RE: **Response to Comments**  
**2011-2012 Dewatering Maintenance Project**  
**Wilson County MSWLF**

An As-Built Drawing of  
**WILSON COUNTY LANDFILL  
 GAS COLLECTION SYSTEM  
 DEWATERING MODIFICATIONS**  
 Wilson County, North Carolina

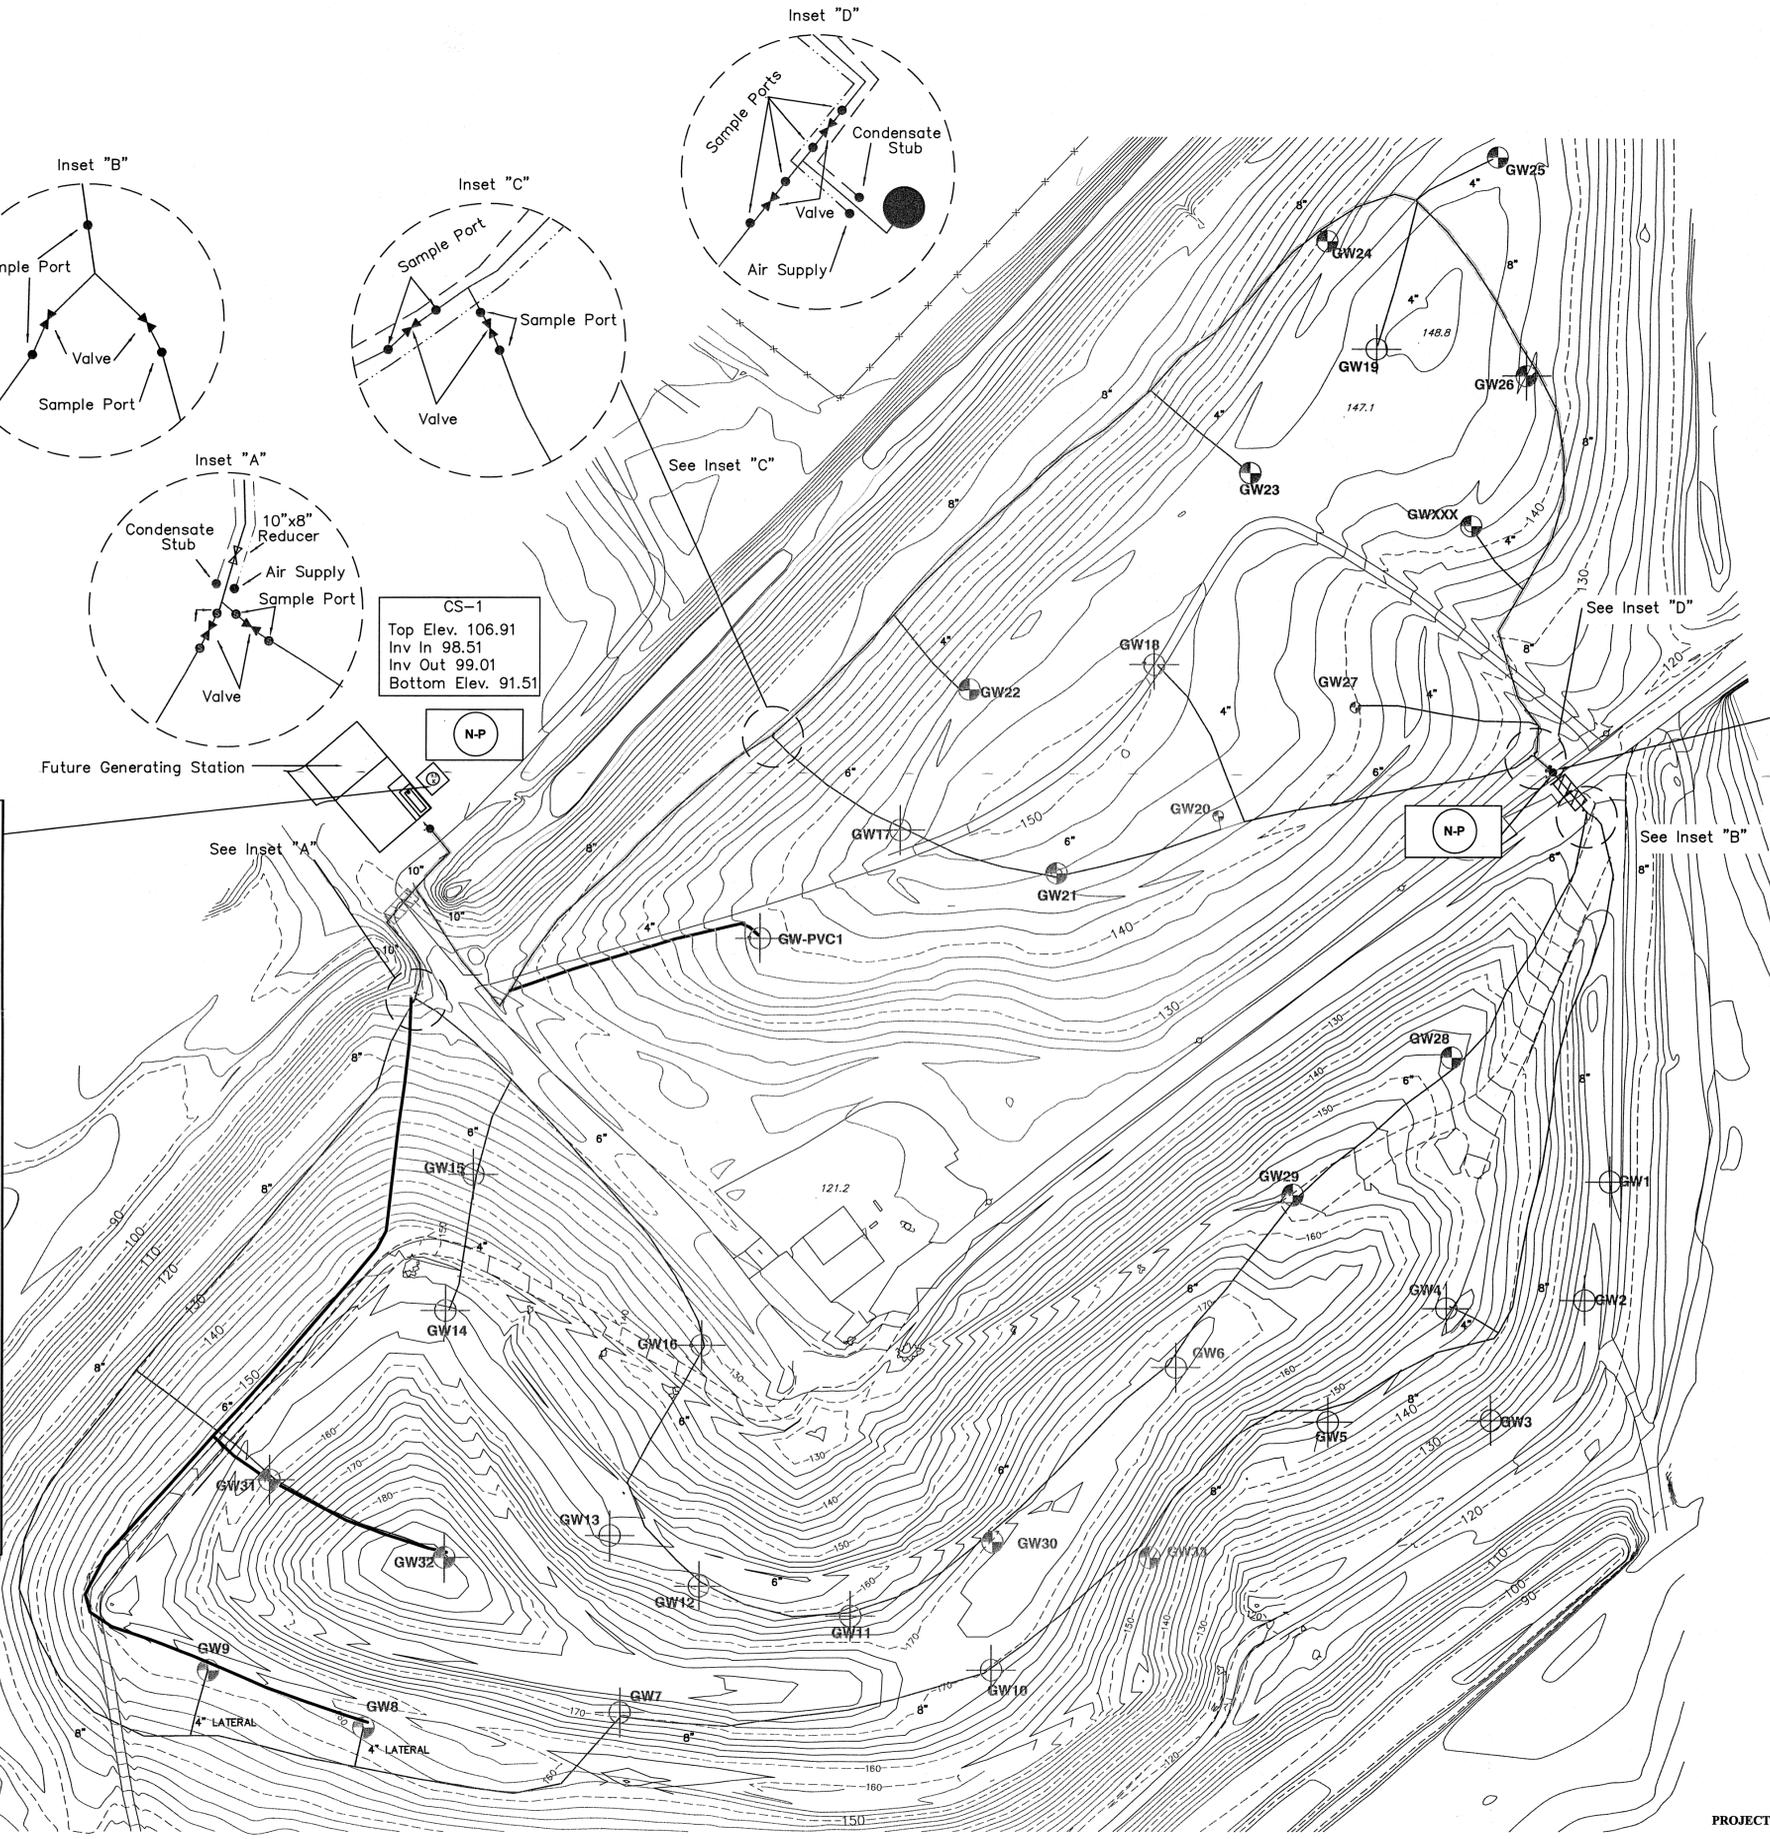
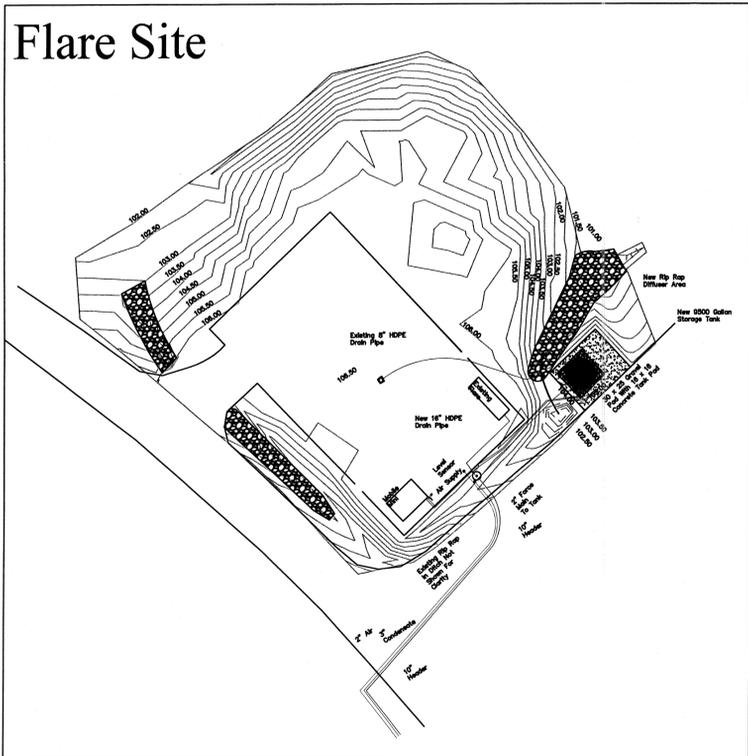
1. The Construction Record (on page 1) didn't describe the status of the two pumps which originally planned to be installed into wells GW-31 & GW-32 according to the approved "Dewatering Maintenance Operation Plan" dated September 2011 (Doc ID 15082). The As-Built Survey/Record Drawing (Sheet 3 of 6) in Attachment B indicated that pumps have been installed into the wells GW-31 & GW-32. Please describe the status of the two pumps associated with wells GW-31 & GW-32; or if there is any deviation from the original plan, please provide the causes resulted in this deviation. If the proposal of installing two pumps had been removed from the original plan during the course of the project, please revise the drawing (Sheet 3 of 6) accordingly.

4. The As-Built Survey/Record Drawing (Sheet 3 of 6) in Attachment B of the Construction Record must be signed, sealed and dated by a Professional Engineer registered in the State of North Carolina or a NC licensed surveyor.

5. According to the photo (on Page 2 in Attachment D) the identification numbers of the well GW-9 has been changed into EW-9. Has the change been done at all gas wells or just at the selected gas wells which involve to the Dewatering Project? Please clarify. To avoid any confusion in the future, please describe the variation of well identifications and revise the as-built drawing accordingly.

**Pumps were not installed in wells GW-31 and GW-32. They were removed from the original plan once it became evident that the pumps installed in GW-8 and GW-9 were causing moderate drawdown of the water levels in GW-31 and GW-32. A revised Record Drawing attached to this letter reflects this change.**

Please find attached the revised Record Drawing that has been signed, sealed, and dated by a NC licensed surveyor.

Temporary well identification numbers were used during construction and were not removed from the wells prior to taking the project completion photographs. The facility has relabeled each well so that they correspond to the identification numbers shown on the Record Drawing.
